**From:** Kosky, Ken [KKosky@GOLDER.com]  
**Sent:** Tuesday, August 12, 2003 9:55 AM  
**To:** Heron, Teresa  
**Cc:** Farzie Shelton (Farzie.Shelton@lakelandelectric.com)  
**Subject:** Lakeland Electric Larsen Unit 8

**RE: DEP File No. 105003-008-AC; PSD-FL-166(D)  
Lakeland Electric, Charles Larsen Power Plant  
Combined Cycle Unit 8 – Peak Operation and Turbine Upgrades**

RE: DEP File No. 105003-008-AC; PSD-FL-166(D)  
City of Lakeland, Charles Larsen Power Plant  
Combined Cycle Unit 8 – Peak Operation and Turbine Upgrades  
Request for Information

Re: DEP File No. PSD-FL-166(D) and 1050003-<sup>012</sup>~~008~~-AC  
Charles Larsen Memorial Power Plant – Combined Cycle Unit 8  
Increase of Heat Input Rate and Peak Mode Operation Request

Based on a constant specific humidity of 0.0064 lbs of water per pound of dry air, except for temperatures below 45 deg F, where fully saturated air results in a lower specific humidity.

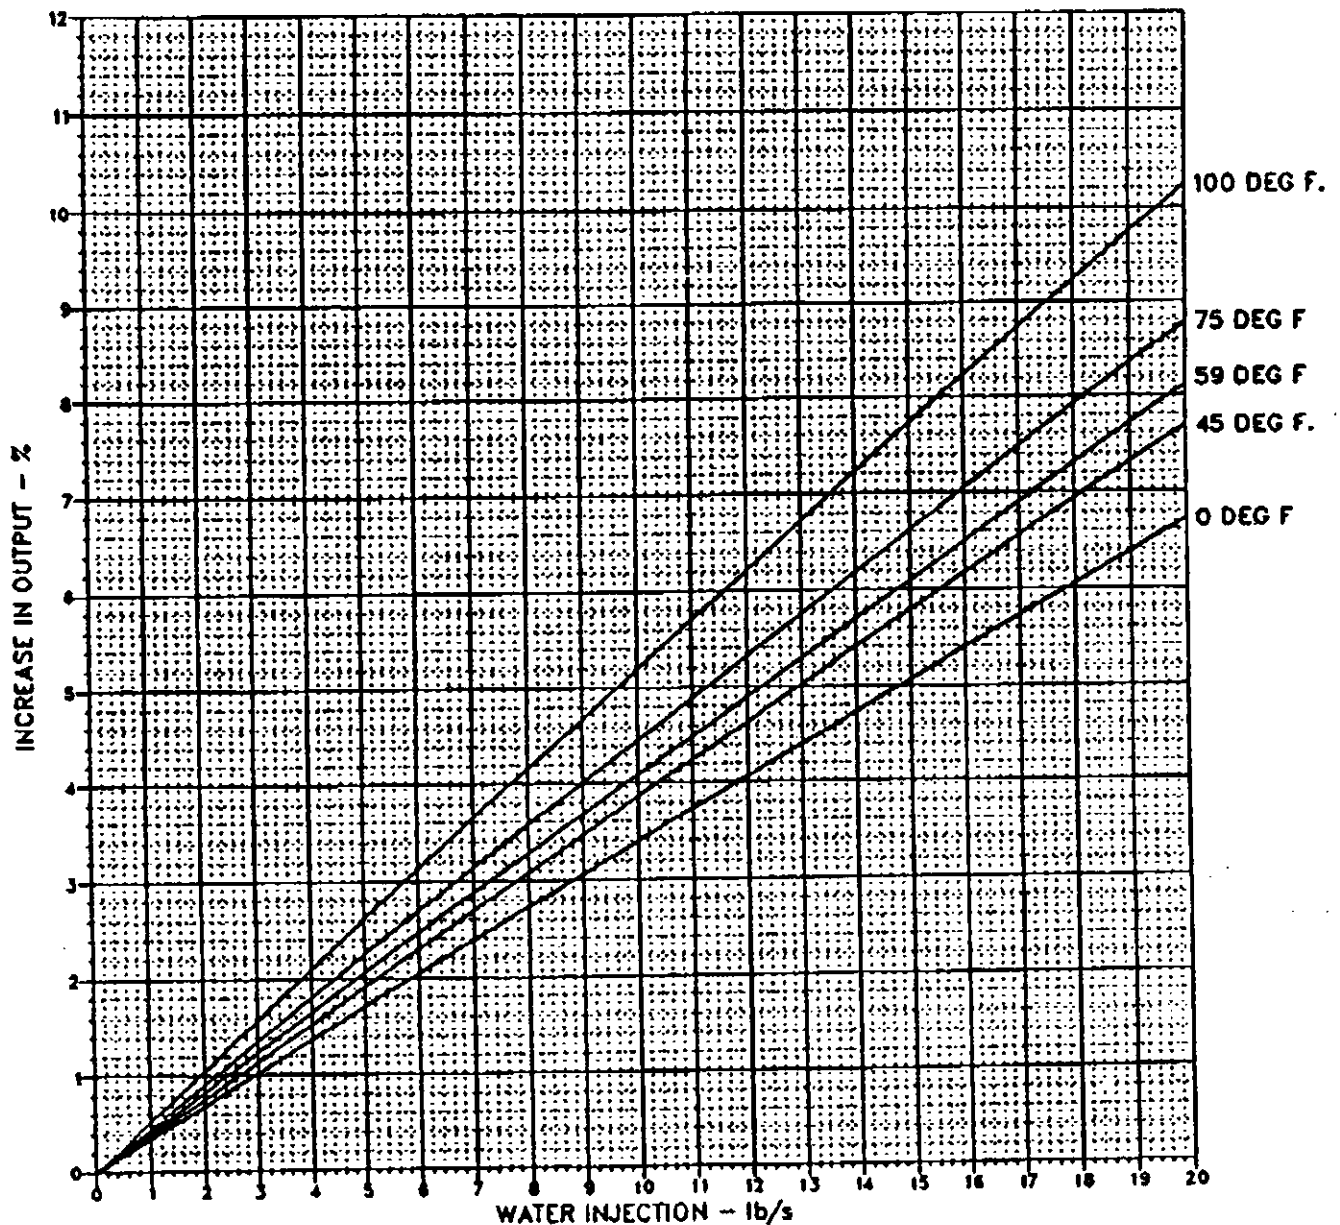
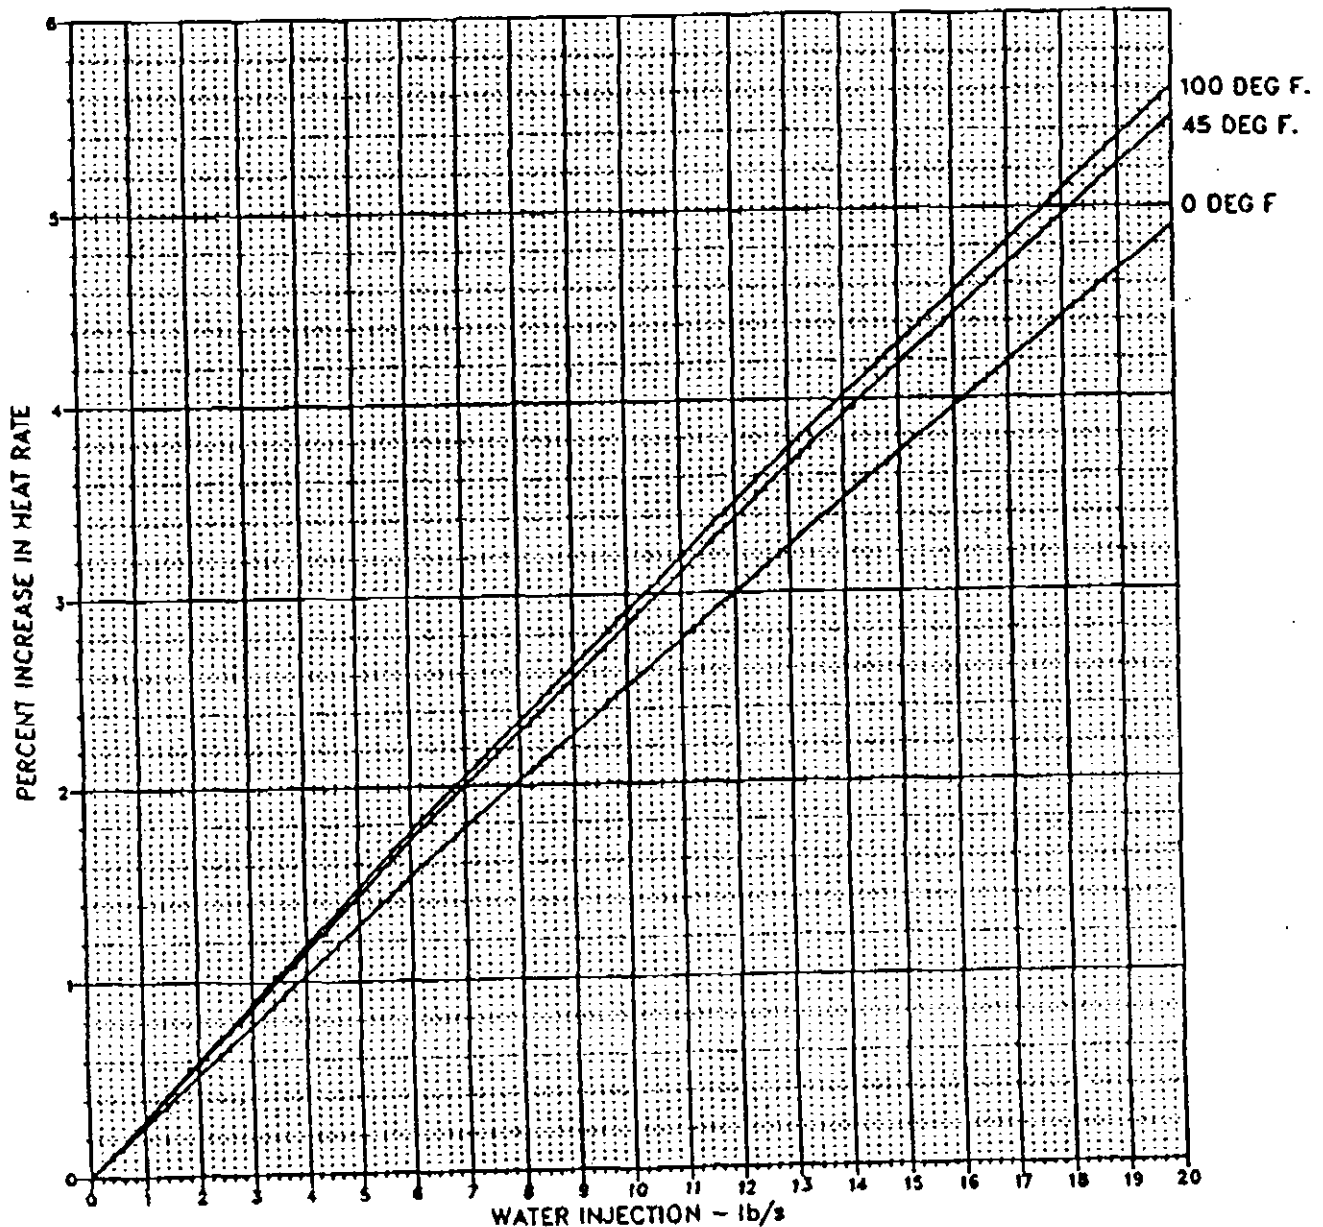
4. Please supply the manufacturer's specifications for the GE Model PG 7111EA.

4. **GE Model PG 7111EA Specifications:** The GE performance curves for the PG 7111EA combustion turbine operating in both baseload and peak mode are attached. As noted by the

dates of these curves, Peak Mode operation was included in the original design of Unit 8.  
The heat input limit in the original permit however reflected baseload operation.
